Access Compliance Report Public Rights-of-Way (Pedestrian Signals)

Main Street: ORANGEWOOD_AVE Cross Street: LOS_ALAMITOS_BLV Location: NW

ADA ID: SGRK211217120852 Signal Type: One Push Button-Non APS Overall Compliance: No Severity Scores: BTN 1: 35 BTN 2: N/A No BTN: N/A

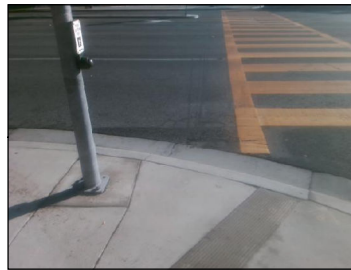
OC Std/PROW: R404.2, R404.3, MUTCD 4e.08

Possible Solutions: Replace Signal Push Button With APS Button. Remove and Replace Clear Space.
